DOMINION NUCLEAR CONNECTICUT, INC.
MILLSTONE POWER STATION UNIT 2
CORE OPERATING LIMITS REPORT, CYCLE 21

In accordance with the Millstone Power Station Unit 2 (MPS2) Technical Specifications (TSs), Section 6.9.1.8.d, Dominion Nuclear Connecticut, Inc., hereby submits, as Enclosure 1, the Cycle 21 Core Operating Limits Report (COLR).

MILLSTONE POWER STATION UNIT 2
CORE OPERATING LIMITS REPORT, CYCLE 21

APPENDIX 8.1 CORE OPERATING LIMITS REPORT, CYCLE 21

Figure 2.5-1
AXIAL SHAPE INDEX vs.
PERCENT OF ALLOWABLE POWER LEVEL

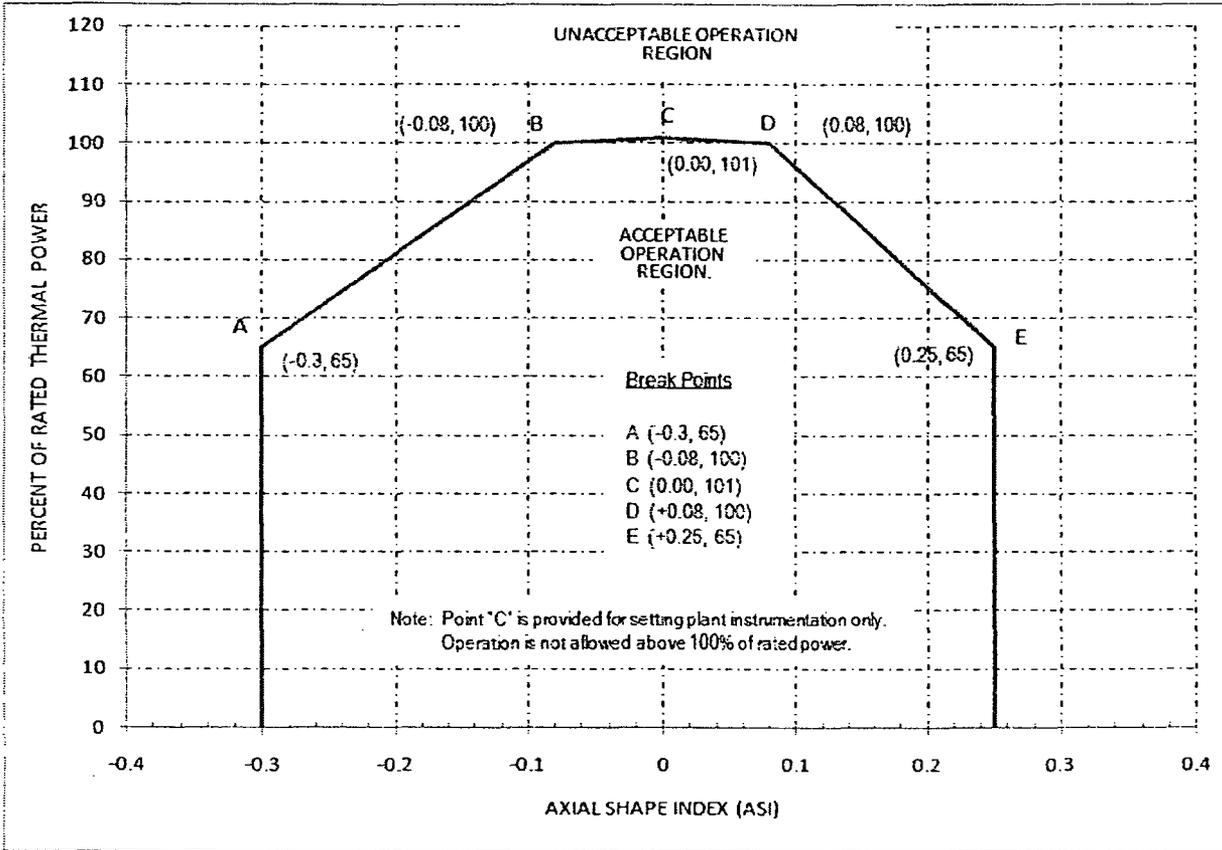
- Revision to page headers to reflect Cycle 21.
- Addition of a penalty factor to account for the impact of the offset incore instrument (ICI) detectors on the linear heat rate measurement.
- Revision to Figure 2.5-1 based on the analysis supporting the offset ICI detectors.

During operation with the linear heat rate being monitored by the Excore Detector Monitoring System, the AXIAL SHAPE INDEX shall remain within the limits of Figure 2.5-1.
